REMEDIATION SYSTEM EVALUATION (RSE)

57TH AND NORTH BROADWAY SITE

WICHITA, KANSAS

Report of the Remediation System Evaluation

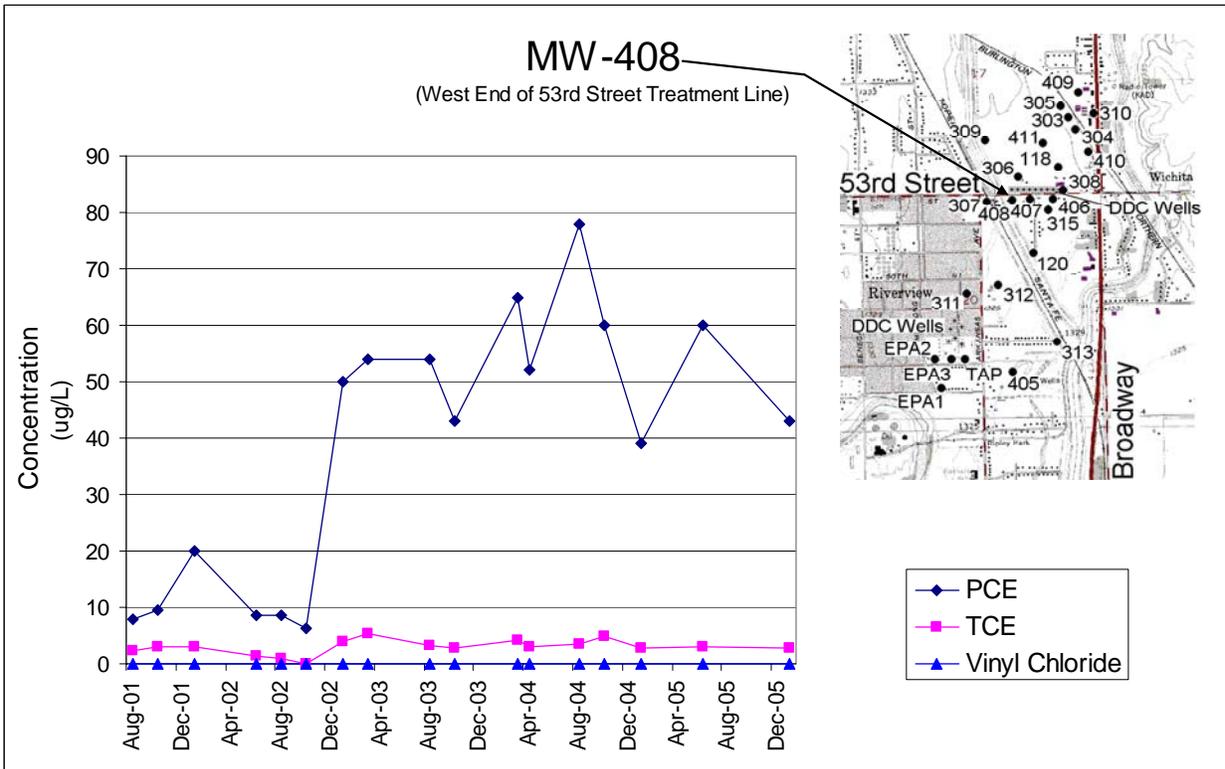
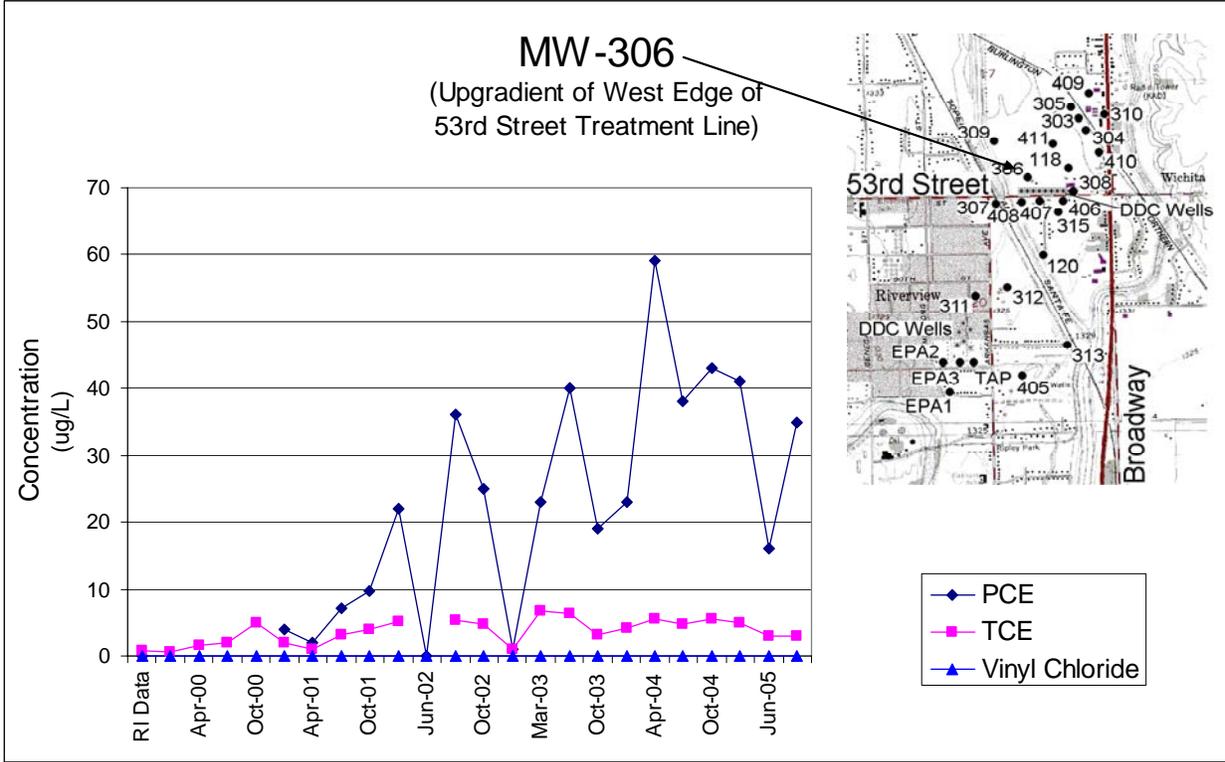
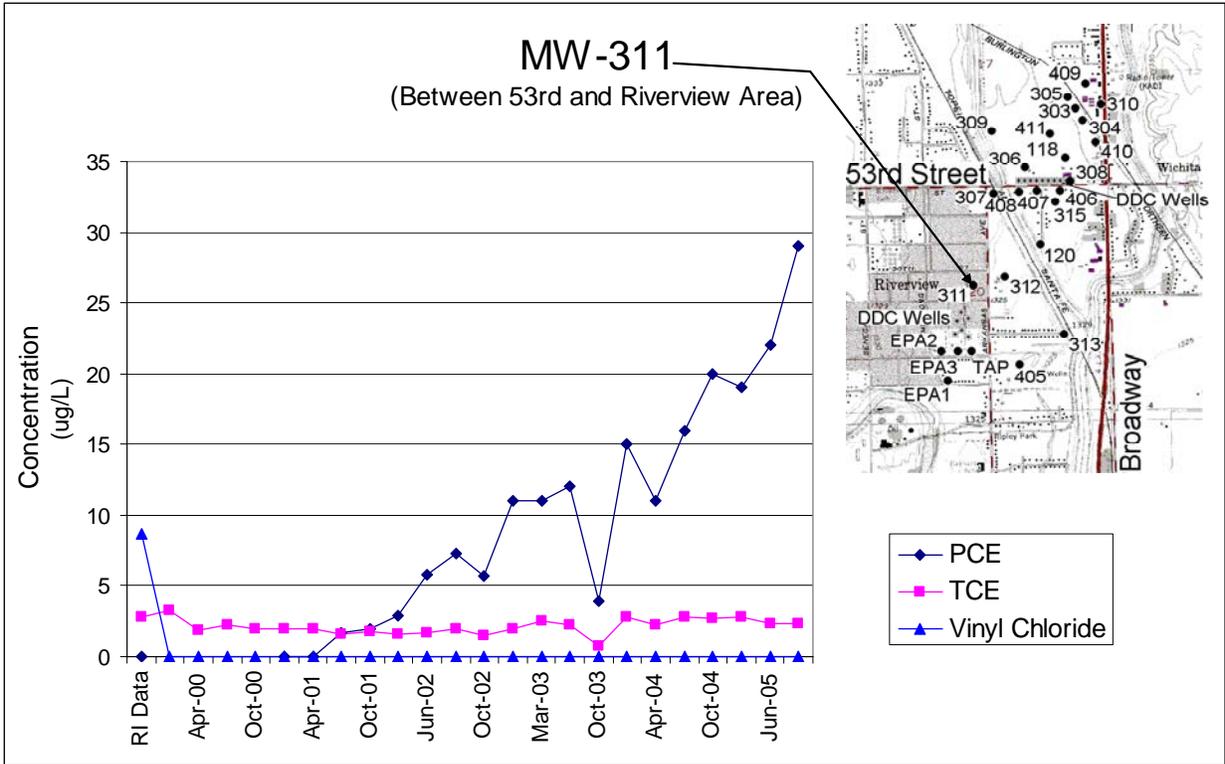
The site ground water plume is generally defined as PCE concentrations above MCLs. Relatively high PCE concentrations are observed in monitoring wells located along the western edge of the plume such as MW-306 and MW-408, and concentrations have been increasing at MW-311 which is located further downgradient. Concentration histories at these wells are illustrated below.

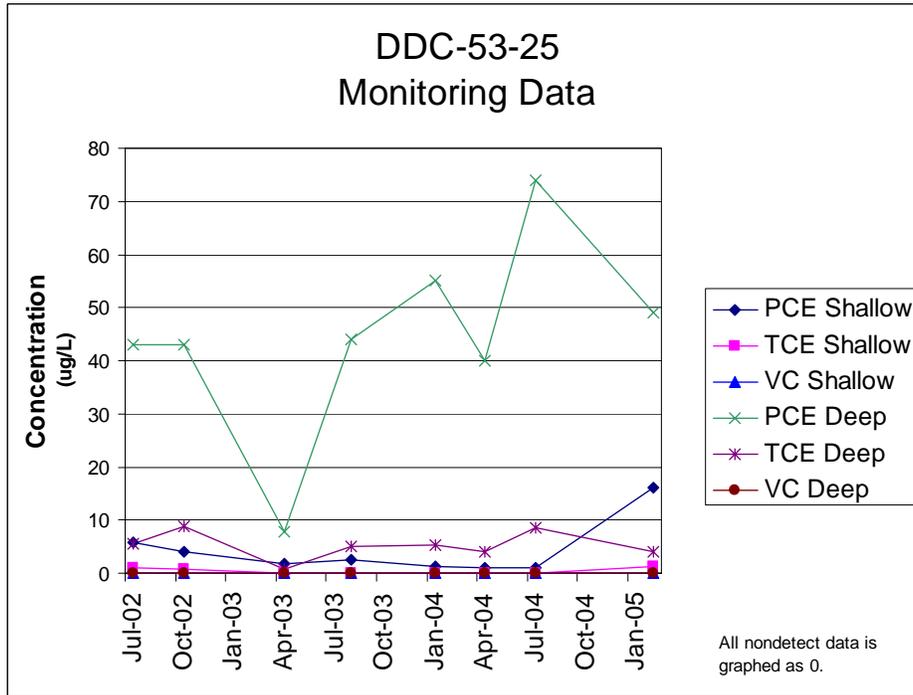
Similarly PCE concentrations greater than 50 ug/l have also been observed in the deep observation wells of the western-most DDC wells (DDC-53-22D to DDC-53-25D). The concentration history associated with the western-most DDC well is provided below.

Note that shallow concentrations near active DDC wells may be lower than deeper concentrations due to discharge of treated water in the shallow interval.

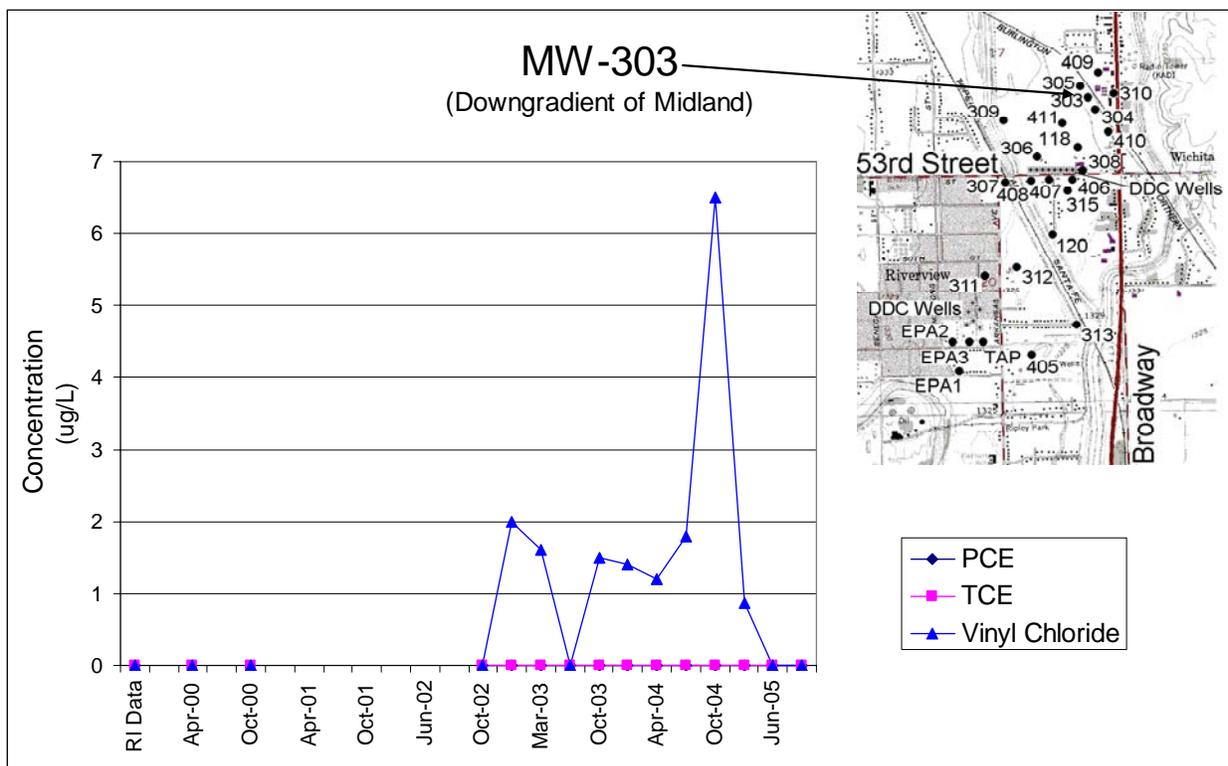
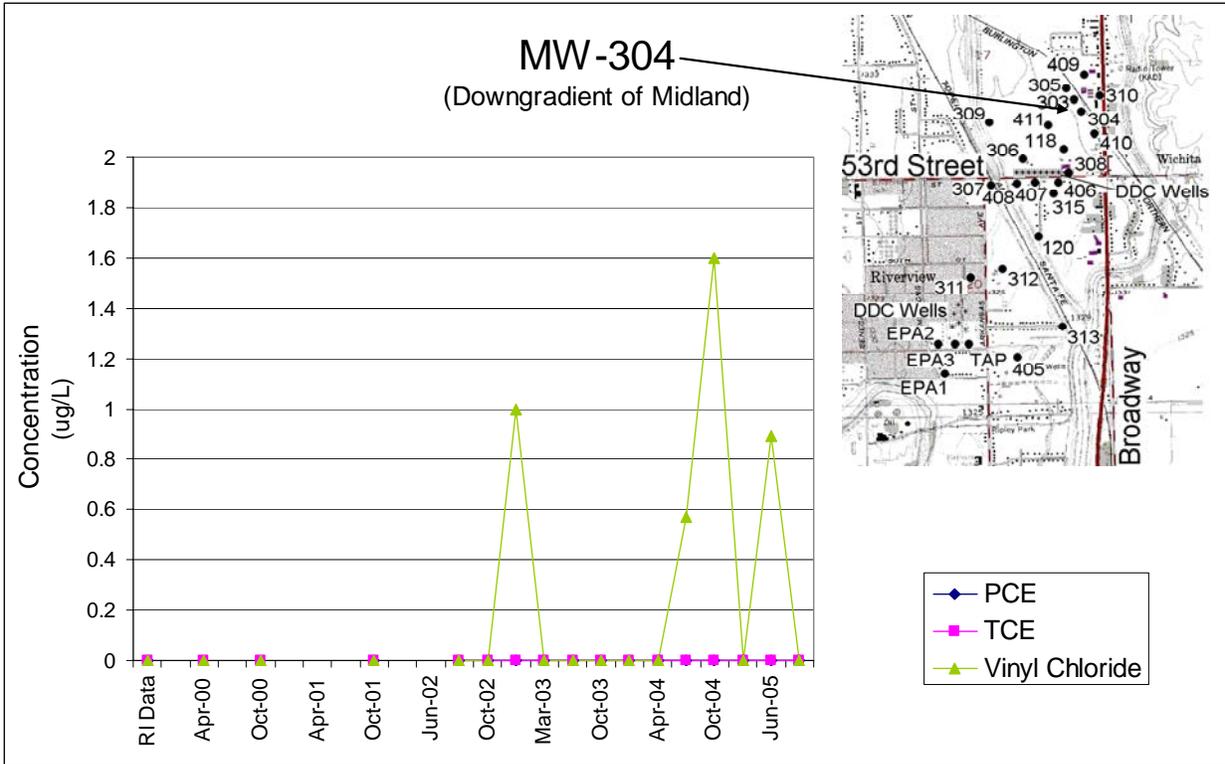
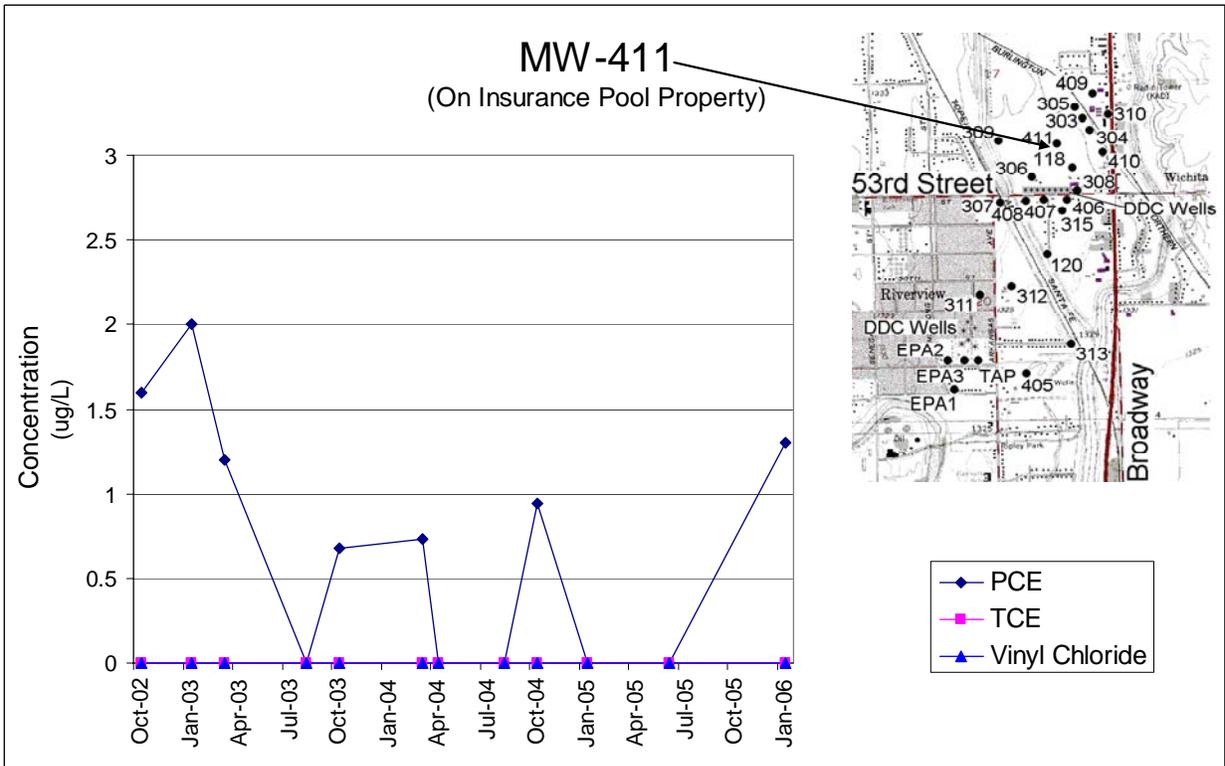
Another uncertainty regarding Midland being the only significant remaining source is that there are relatively “clean” wells between Midland and the remediation system, such as MW-303, MW-304, and MW-411. Concentration histories for these wells are illustrated below.

However, the RSE team notes that these relatively “clean” wells might not show impacts due to their screen interval (i.e., they might be screened above or below the contamination), but not enough information has been provided to the RSE team to establish this conclusion. A conceptual illustration was provided by KDHE to highlight this point, but a vertical scale indicating actual well screen elevations was not included, and more detailed evaluation would be required.

Due to these uncertainties, it was suggested during the site visit that the relatively new wood composting facility located just north of 53rd Street (near the western portion of the DDC barrier system) could potentially be an additional source. This was previously vacant land. There was general agreement that additional source area characterization is likely merited.

Figure 2 Groundwater Contours - January 2006

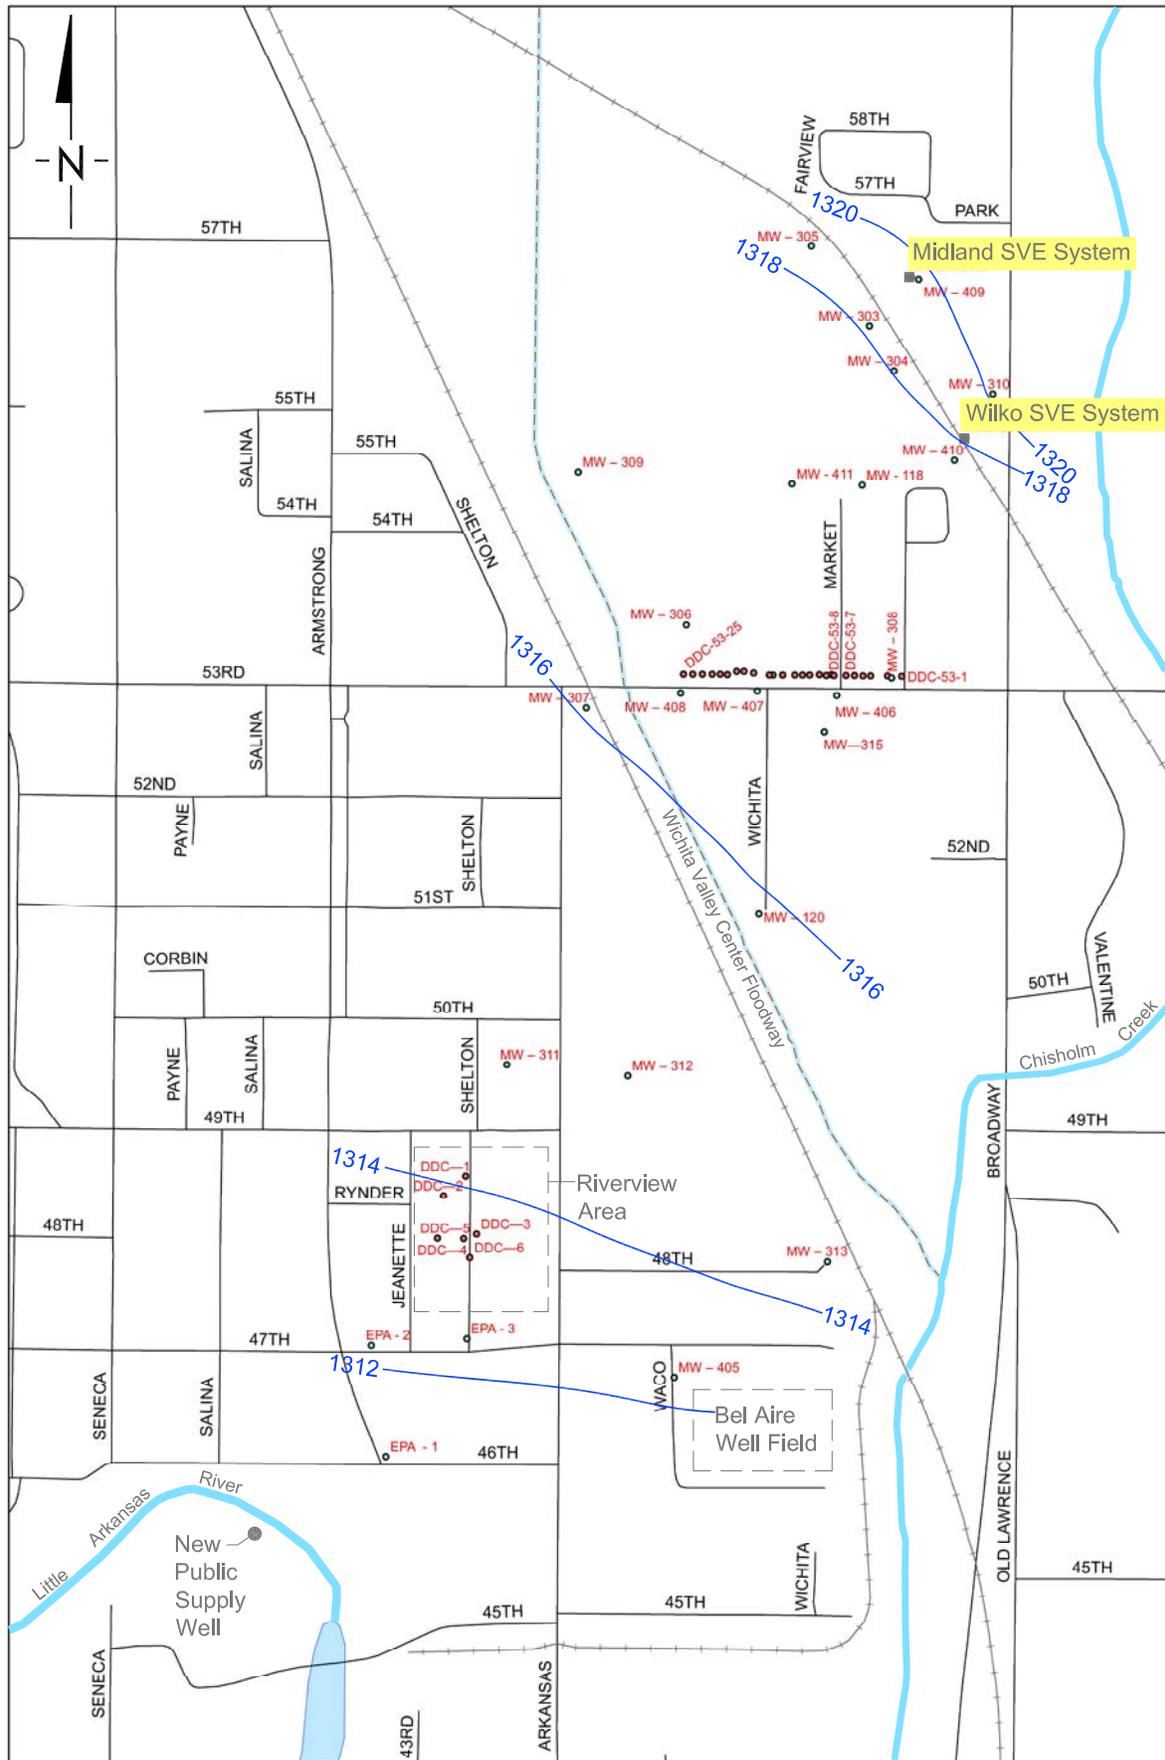
Site wide static water level measurements are collected but are not formally reported in tables or water level maps. However, previous investigations have consistently determined that ground water flow is generally in the southwest direction. The RSE team constructed a water level map from the January 2006 water level data provided by USEPA after the site visit. This map is presented in Figure 2. It is consistent with ground water flow to the southwest.
